## **CUSTOM LALA UNIT – WITH UNDERSLUNG BASIN**

Name: LALA CABINET  
QTY: X1

Dimensions: 1500 L x **600 W** x 900mm H

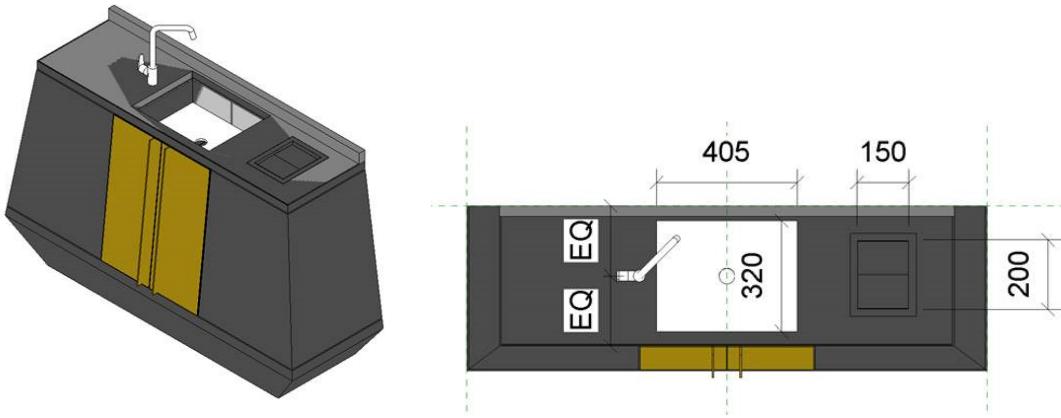
A. As per previous communication, Please note that we need a cut-out in the base of this unit; Due to the raft foundations, the plumbing won't be coming through the wall behind the cabinet as standard practice.

opening flush with the back of the unit [so no structural element can cross this cut-out] for the unit to slot around the 110mm dia. pipe protruding from the slab;

**We propose this cut-out is at least 400mm wide x 200mm from back to front so the main contractor have play around this 110mm pipe to ensure the unit is centred to the wall;**

Underslung - Swift

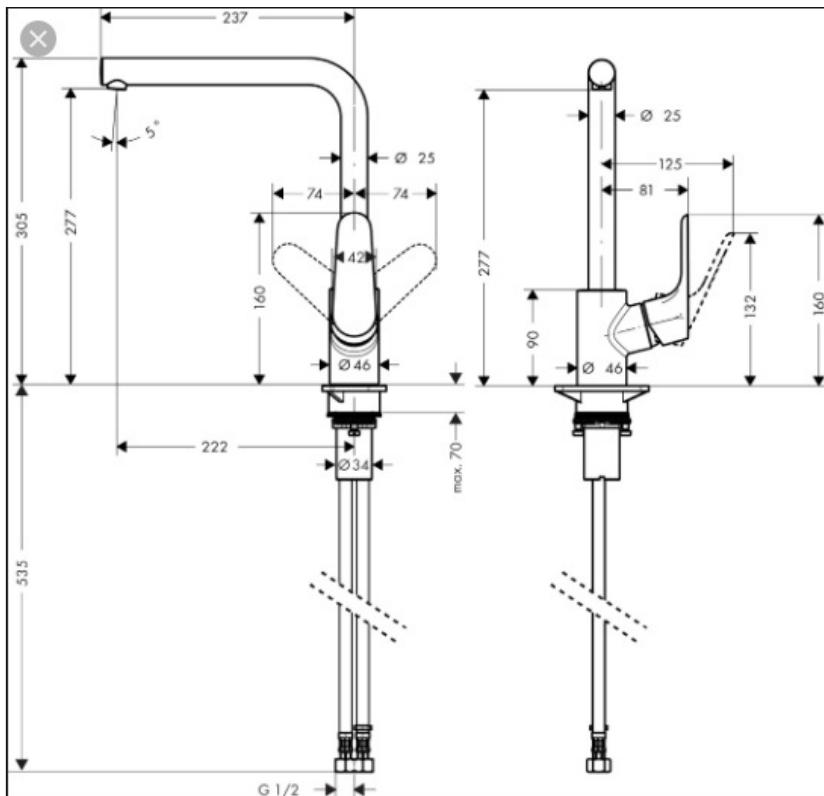
- a. We would love to use the same design for Nando's Gezina Drive Thru, Graphite Black unit with Acid Yellow colour block doors.
- b. Adriaan confirmed per email the last time that he made the standard Lala unit **600mm deeper to fit the basin**. Please can we do this again for this unit.
- c. Provide the **150 x 200mm flip-top [graphite black] in the granite top** on the right side of the basin;
- d. Bin to fit underneath this hole with flip-top;  
Nando's will supply the bin; bin size of 300 x 300 x 550-H will fit;
- e. We ordered the following basin from Rossco for Northmead Drive Thru and want to use the same spec.  
Supplier: Rossco  
Name: Underslung – Swift  
Size: The internal measurements are: **Medium basin [405mm L x 320mm W [front to back] [code: SWUSM]**

- Small: 360mm (A) x 310mm (B) - Code: SWUSS
- **Medium: 405mm (A) x 320mm (B) - Code: SWUSM**
- Large: 520mm (A) x 340mm (B) - Code: SWUSL (White) / SWUSLB (Black)

*Remember to cut the granite slightly smaller than the internal measurements of the basin. 15mm smaller should work well.*
